SERVICE BULLETIN

N° 189-278

ATA 21 - ECS ELECTRIC LINES CLIPPING MODIFICATION

Figure 1

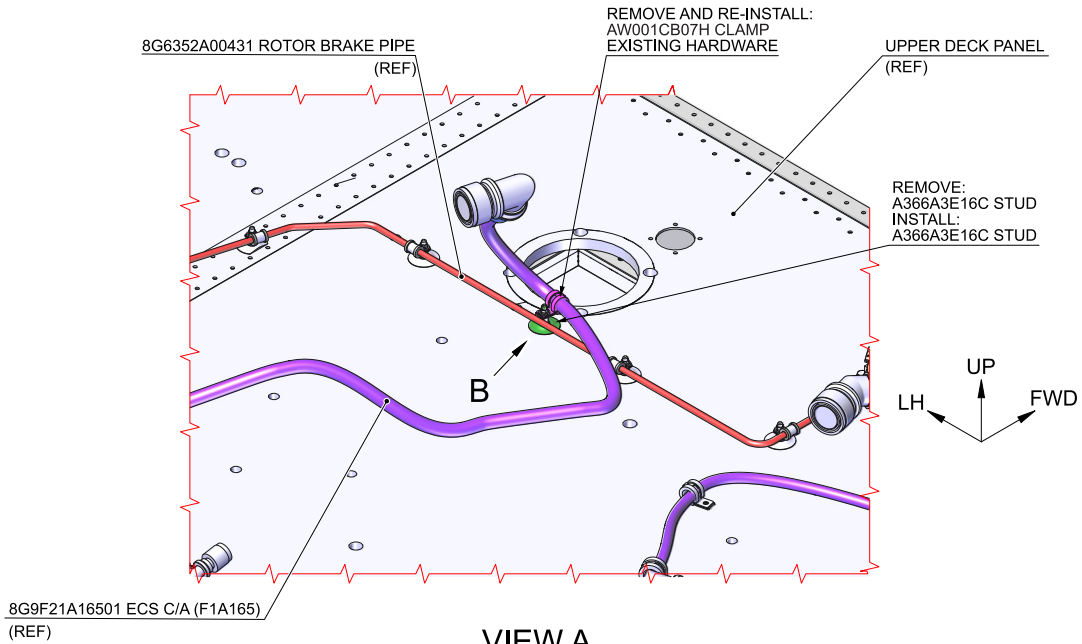
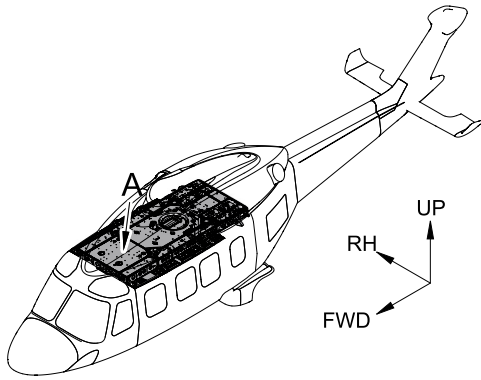
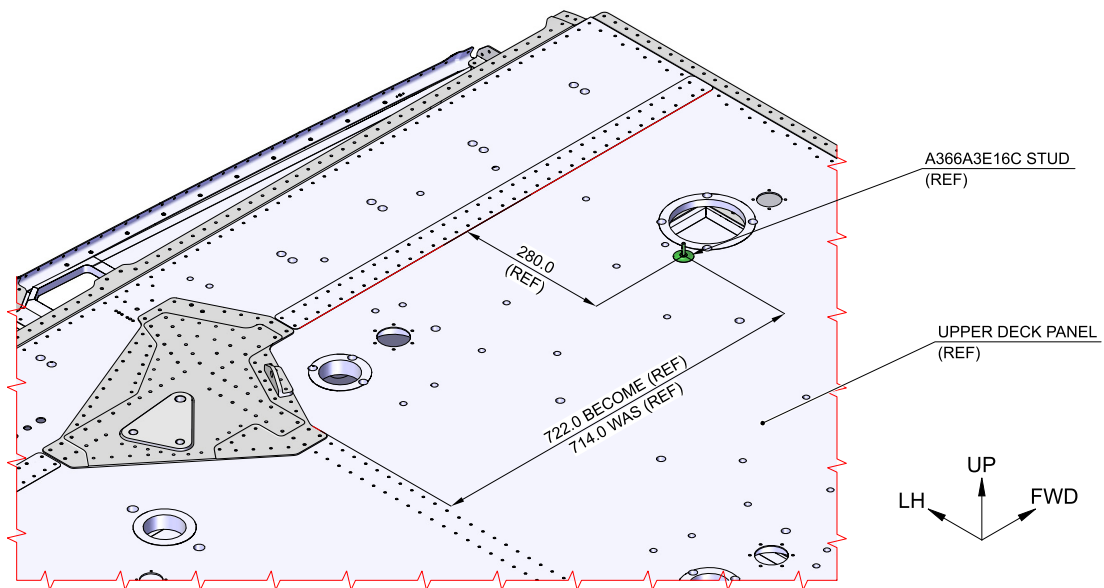
Leonardo Helicopters identified a possible interference on the upper deck between the rotor brake hydraulic line and a stud which is part of the ECS kit electrical harness clipping.

This Service Bulletin gives instructions on how to change the ECS cable path, repositioning the stud in a new position and avoid any possibility of interference with the rotor brake pipe assy P/N 8G6352A00431.

- 2.1 With reference to Figure 1 View A, remove and retain the clamp P/N AW001CB07H and its fixing hardware from the existing stud P/N A366A3E16C.
 - 2.2 In accordance with the applicable steps of AMP DM 89-A-20-10-16-02A-920A-A and with reference to Figure 1 View A, remove the stud P/N A366A3E16C from the upper deck panel.

- 2.3 In accordance with the applicable steps of AMP DM 89-A-20-10-16-02A-920A-A and with reference to Figure 1 View A and View B, install the stud P/N A366A3E16C in the new position on the upper deck panel in accordance with the dimensions shown.

- 2.4 With reference to Figure 1 View A, re-install the clamp P/N AW001CB07H previously removed on the stud P/N A366A3E16C by means of the existing hardware.
